ISSUE: Certificate of Appropriateness for alterations

LOCATION: Old and Historic District
913 South Alfred Street

BAR#2026-00032 - OHAD
913 South Alfred Street

The applicant requests a Certificate of Appropriateness for alterations to construct a rear deck addition and convert a rear window into a patio door.

Figure 2. Proposed rear elevation.

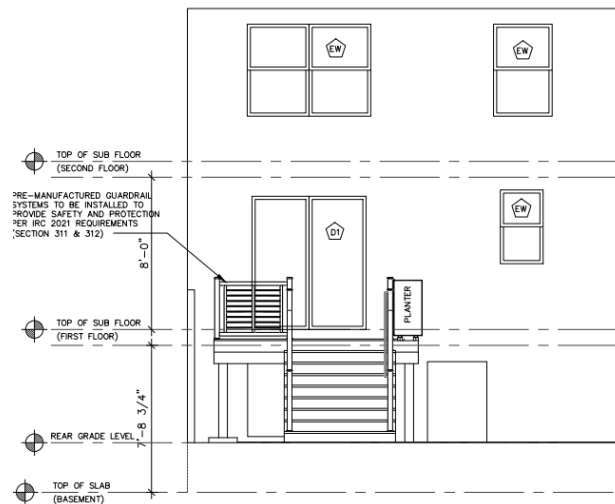
The applicant requests a Certificate of Appropriateness for alterations to construct a rear deck addition (Figure 2). The new deck will be 4-5 feet above grade and will have black aluminum railings. Additionally, an existing window will be converted into a sliding patio door. The patio door will be a Loewen aluminum-clad wood door. The amount of existing window and wall being removed is less than 25 square feet, so a Permit to Demolish is not required.

According to the *Design Guidelines*, "...railings should have a design that is appropriate to the architectural style of the structure and be made of materials such as wood, cast iron, precast concrete, or stone". Additionally, "rails should be minimal in appearance".

The proposed deck railing is simple in design and the aluminum material is appropriate for this Later building. The design is also consistent with other rear decks that have been approved by the BAR on this block in the past. Additionally, the view of the rear of the house is partially blocked by the fence, making the deck minimally visible. Lastly, the proposed conversion of a window into a sliding patio door will not detract from any historically significant features on the house, and the proposed door's material is appropriate. In the opinion of staff, the proposed alterations are sympathetic to the architectural style of the building.

Therefore, staff recommends **approval** of the Certificate of Appropriateness for alterations, with the condition that the applicant comply with the comments noted by Alexandria Archaeology.
